Access Compliance Report

Public Rights-of-Way

Intersection ID: 10041519	Main Street: WEYMOUTH_LN	Cross Street: N/A	Location: W
ADA ID: C88BE43AA784	Ramp Type: Perp	Initial Pass/Fail: Fail	Overall Compliance: No
Codes/Mitigation Info/Possible Solution		Field Measurements/Component Compliance	
Severity Score: 13.75

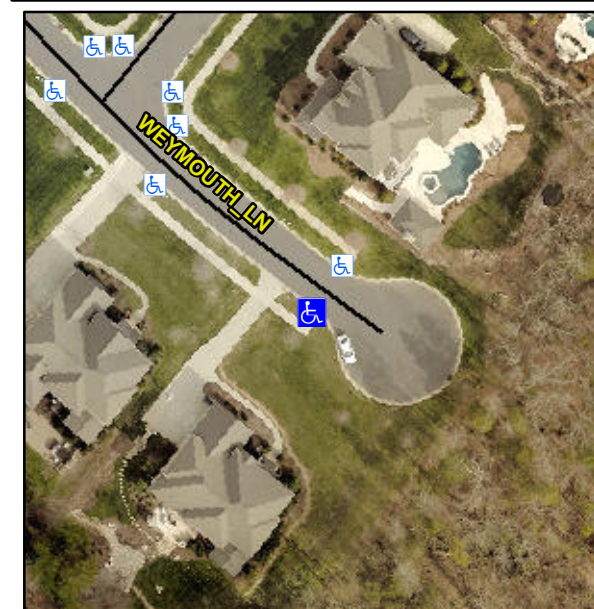
Not Found, R304.2.2, R304.5.3

Compliance	Description	Data	Compliance	Description	Data
N/A	Ramp Length (in)	83.0	No	Ramp Slope (%)	9.1
Yes	Ramp Width (in)	48.0	No	Ramp XSlope (%)	2.3
N/A	Flare Type LT	N/A	N/A	Flare Type RT	N/A
N/A	Flare Slope LT (%)	N/A	N/A	Flare Slope RT (%)	N/A
N/A	Flare Traversable LT?	N/A	N/A	Flare Traversable RT?	N/A
N/A	Landing Length (in)	N/A	N/A	DWS Provided?	N/A
N/A	Landing Width (in)	N/A	N/A	DWS Contrast?	N/A
N/A	Landing Slope (%)	N/A	N/A	DWS Length (in)	N/A
N/A	Landing X Slope (%)	N/A	N/A	DWS Full Width?	N/A
N/A	Landing Curb? (Y/N)	N/A	N/A	DWS Offset (in)	N/A
N/A	Shared Landing?	N/A			
N/A	Gutter Ponding?	N/A	N/A	Gutter Slope (%)	N/A
N/A	Gutter Lip Ht (in)	N/A	N/A	Gutter X Slope (%)	N/A
N/A	Painted X Walk1?	No	N/A	Painted X Walk2?	N/A
	X Walk 1 Direction	To NE		X Walk 2 Direction	N/A
N/A	X Walk 1 Width (in)	N/A	N/A	X Walk 2 Width (in)	N/A
	X Walk 1 Slope (%)	2.5		X Walk 2 Slope (%)	N/A
	X Walk 1 X Slope (%)	2.0		X Walk 2 X Slope (%)	N/A

Remove & Replace Entire Ramp.
